## DETERMINATION OF NON-SIGNIFICANCE

**FILE NUMBER:** 06-119979-LD

Proposal Title: **112<sup>th</sup> Avenue Mixed-Use**

**City of Bellevue  
Department of Planning and Community Development  
Land Use Division Staff Report**

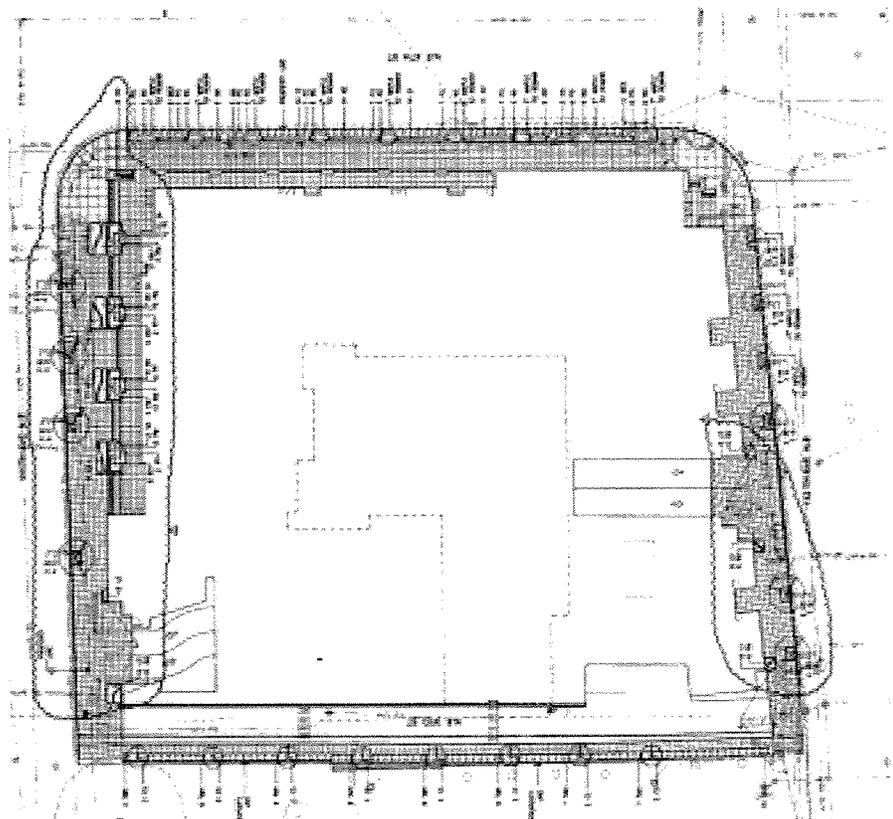
*Please Design Plant  
Spacely Based on MAXIMUM  
PLANT SIZES.*

1. CONSTRUCTURE TREE PLANTING DETAIL

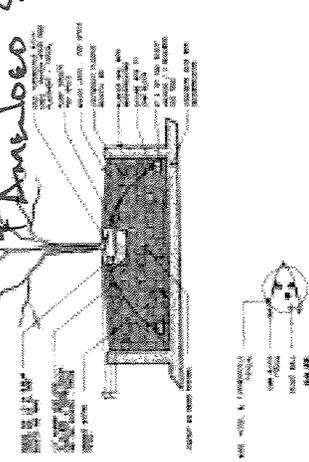
Create Soil reclamation  
 Zones Between North  
 & Amelco SONS.  
 Install 4" PEEL PIPE @  
 BOTTOM OF TREE PITS
